Palo Verde Nuclear
Generating Station

**Subject: Palo Verde Nuclear Generating Station (PVNGS)
Units 1, 2, and 3
Docket Nos. STN 50-528, 50-529, and 50-530
Request for Additional Information, Review of Single Failure Analysis
of Low Pressure Safety Injection Pumps for Minimum Required
Refueling Water Tank (RWT) Transfer Volume**

Response to Request for Additional Information, Review of Single Failure Analysis of Low Pressure Safety Injection Pumps for Minimum Required Refueling Water Tank Transfer Volume

**FIGURE 2
Sketch of PVNGS RWT Vortex Suppressors**

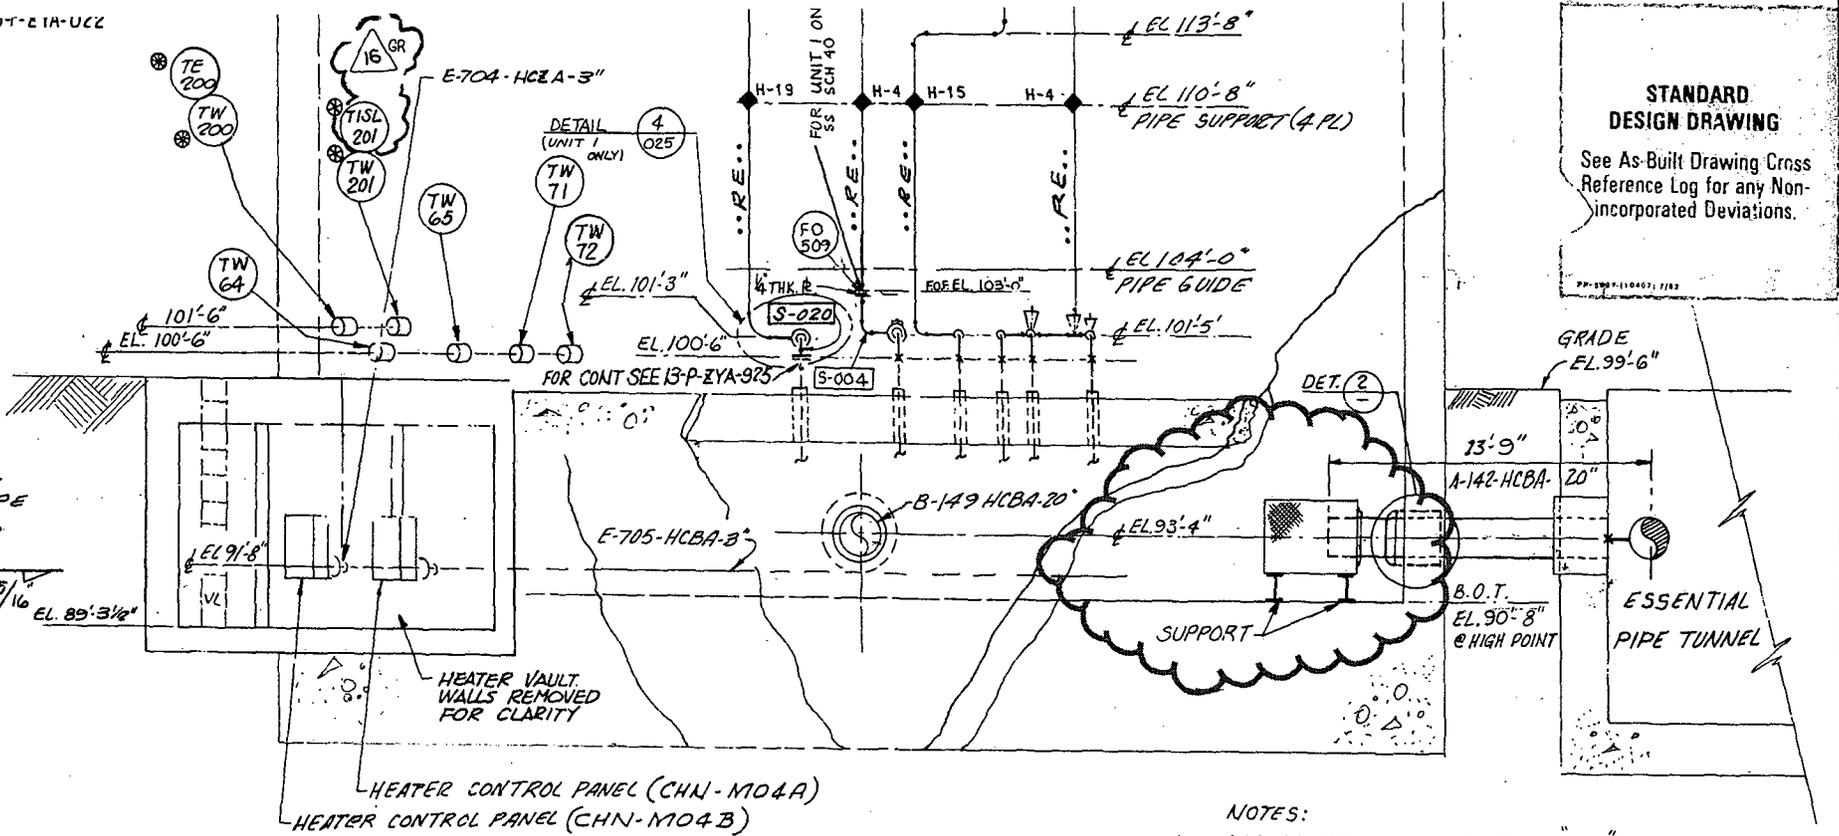
The allowable time for operator action is based on a minimum RWT level that precludes air entrainment. Page 12 of the LAR dated November 30, 2009, states that the RAS setpoint was established to ensure sufficient volume is available after an RAS to credit closure of the RWT discharge valves before the RWT vortex breaker becomes uncovered. Please (a) describe the vortex suppressors, (b) include a sketch of their installation in the RWTs, and (c) provide experimental evidence that establishes their effectiveness in preventing air entrainment.

- (a) The vortex suppressors are constructed of a wire cloth (screening) that is mounted between sections of stainless steel grating on all sides. The grating is 1/8" x 3/4" at 1-3/16" centers with crossbars at 4". The wire cloth in between the grating has a 0.09" opening. Both the wire cloth and the grating function to suppress the vortex. The wire cloth provides a fine screen to catch particles that could be transported with the flow and also helps to impede any swirl flow that could potentially be induced in the RWT as the level decreases. The stainless steel grating provides a large "surface roughness" that projects into and interferes with any large scale circulation pattern, which disrupts coherent swirl that could be initiated during the RWT draindown. These vertical and horizontal protrusions on all sides of the vortex suppressor act to counter any significant vortex formation and 'gulping' of air when the level is above the suppressor device.

- (b) See Figures 1-3 (Attachments 1, 2, and 3 of this submittal) for sketches of the installation of the vortex suppressors in the RWT.
- (c) Experimental evidence that establishes the effectiveness of the vortex suppressors in preventing air entrainment is as follows:
